Proposal #04: 1660-02-73, WISC 2026216
Marquette – Prairie du Chien
Main St Intersection
USH 18
Crawford County

This is Addendum No. 01, which provides for the following:

ADDENDUM NO. 01
1660-02-73, 1660-02-75
February 23, 2026

Addendum No. 01
ID 1660-02-73
Revised Sheet 76
February 23, 2026

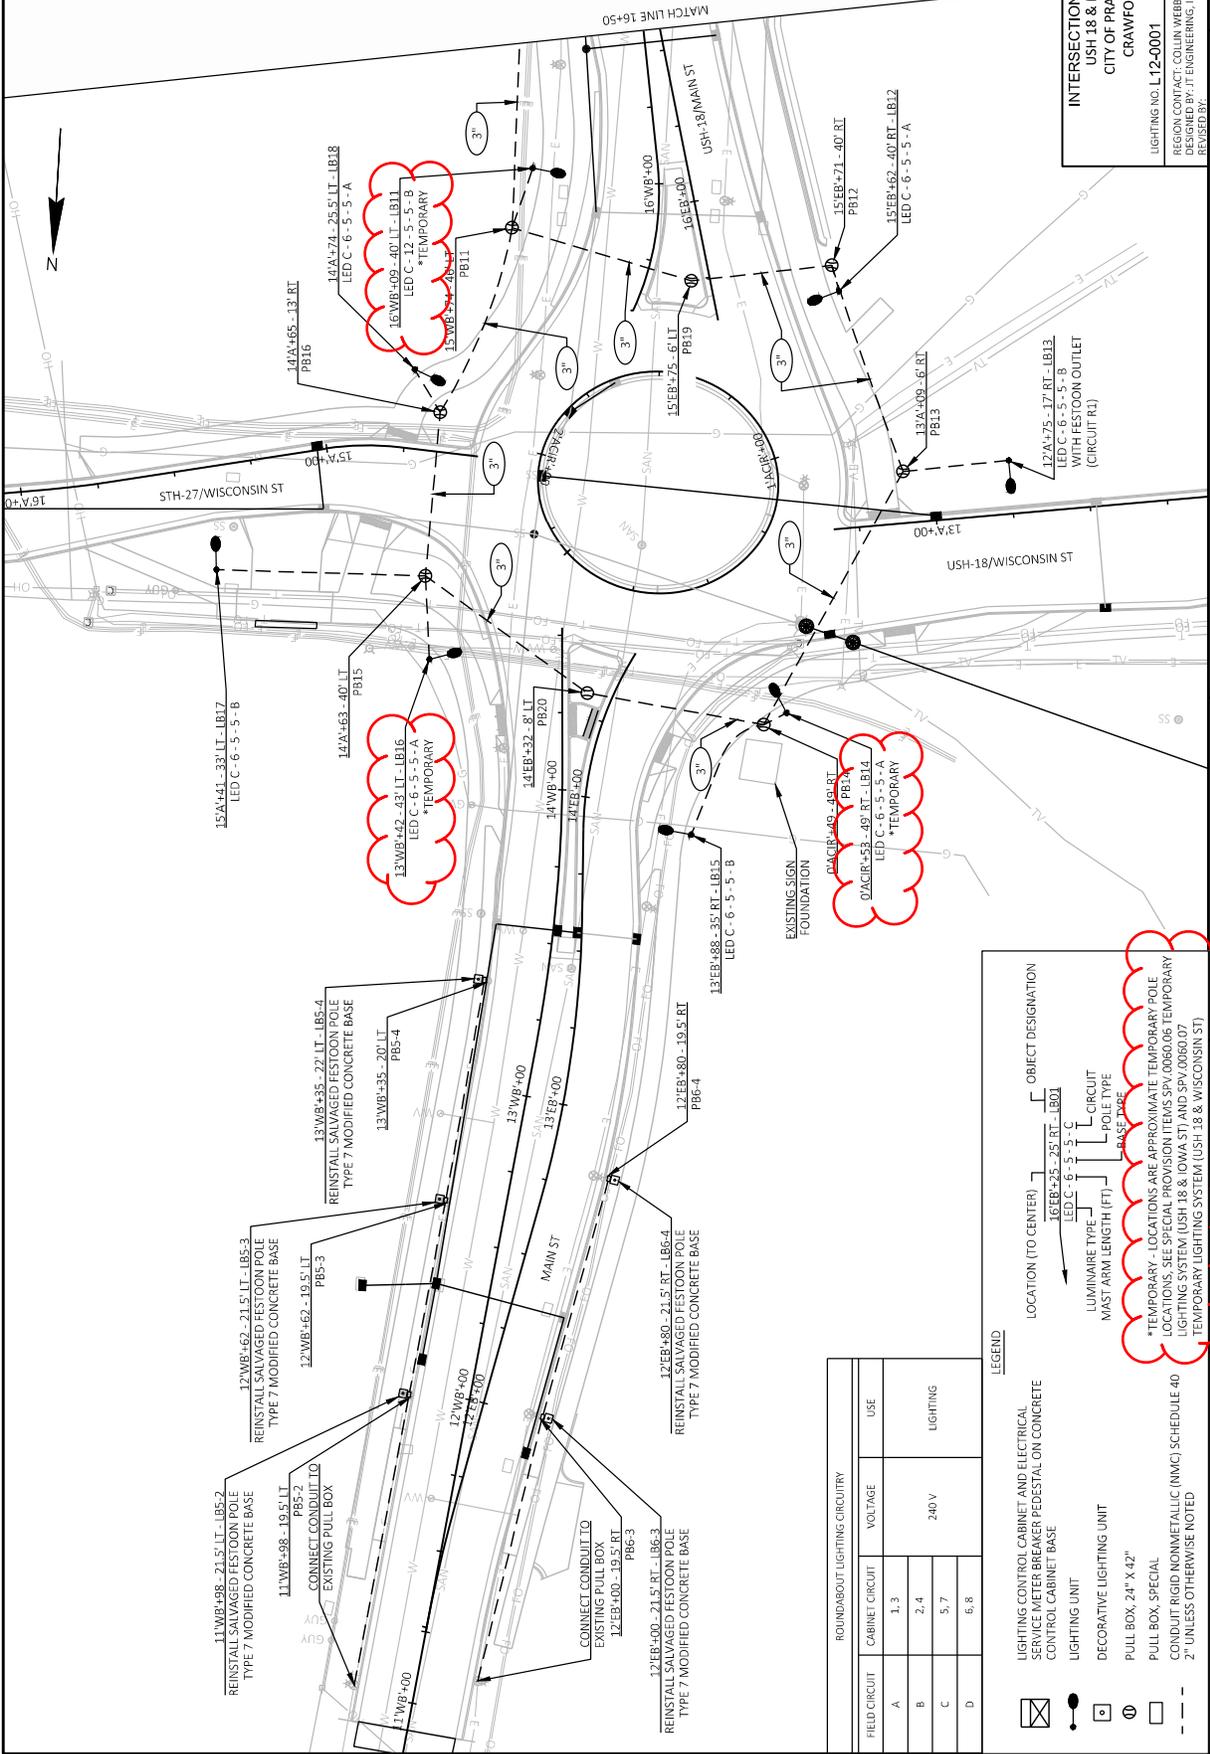
Revised Plan Sheets	
Plan Sheet	Plan Sheet Title (brief description of changes to sheet)
76-77	Lighting Plan – added locations for temporary light poles
135	Miscellaneous Quantities – added Temporary Lighting System items

*TEMPORARY - LOCATIONS ARE APPROXIMATE TEMPORARY POLE LOCATIONS. SEE SPECIAL PROVISION ITEMS SPV.0060.06 TEMPORARY LIGHTING SYSTEM (USH 18 & IOWA ST) AND SPV.0060.07 TEMPORARY LIGHTING SYSTEM (USH 18 & WISCONSIN ST)

Addendum No. 01
ID 1660-02-73
Revised Sheet 77
February 23, 2026

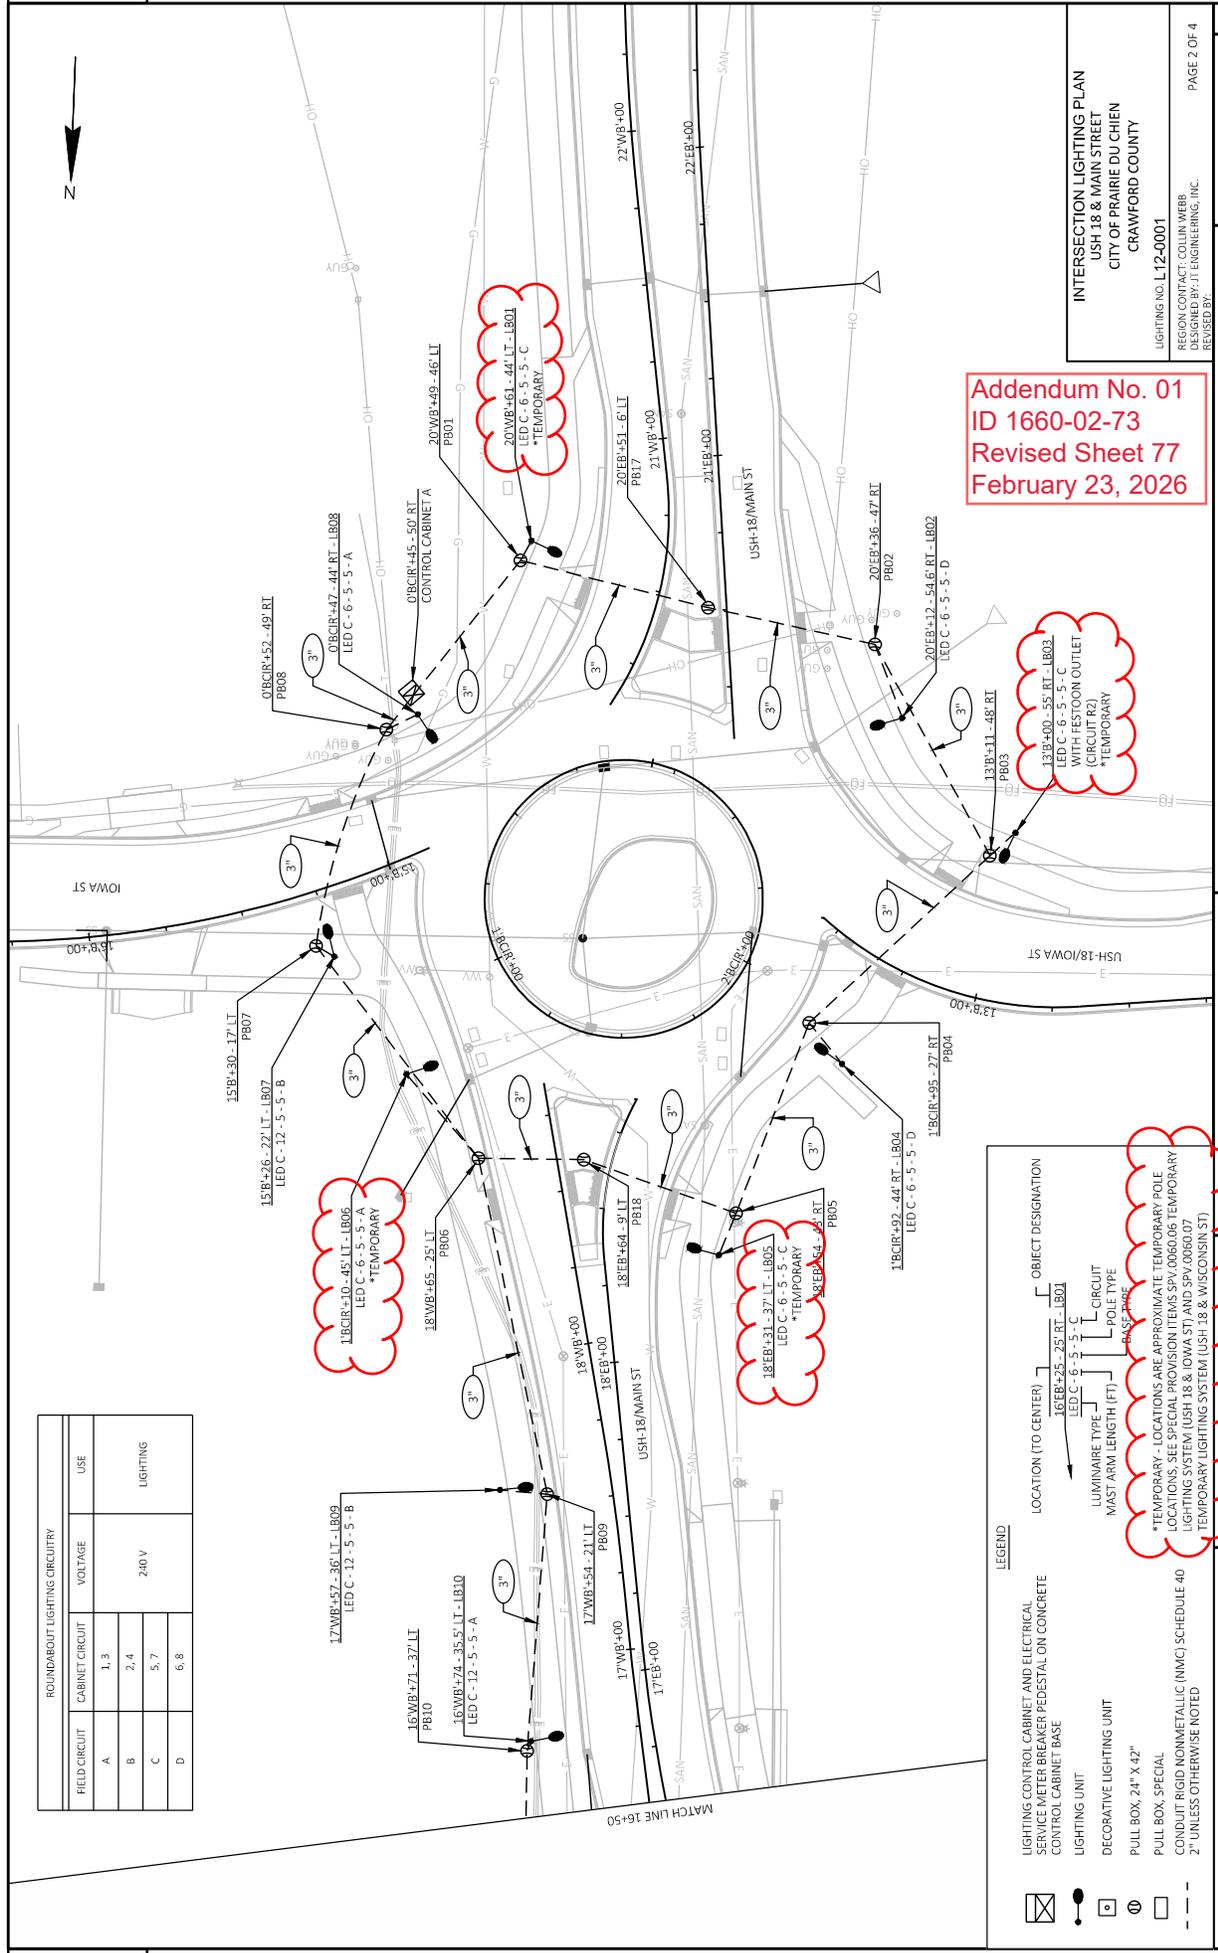
*TEMPORARY - LOCATIONS ARE APPROXIMATE TEMPORARY POLE LOCATIONS. SEE SPECIAL PROVISION ITEMS SPV.0060.06 TEMPORARY LIGHTING SYSTEM (USH-18 & IOWA ST) AND SPV.0060.07 TEMPORARY LIGHTING SYSTEM (USH-18 & WISCONSIN ST)
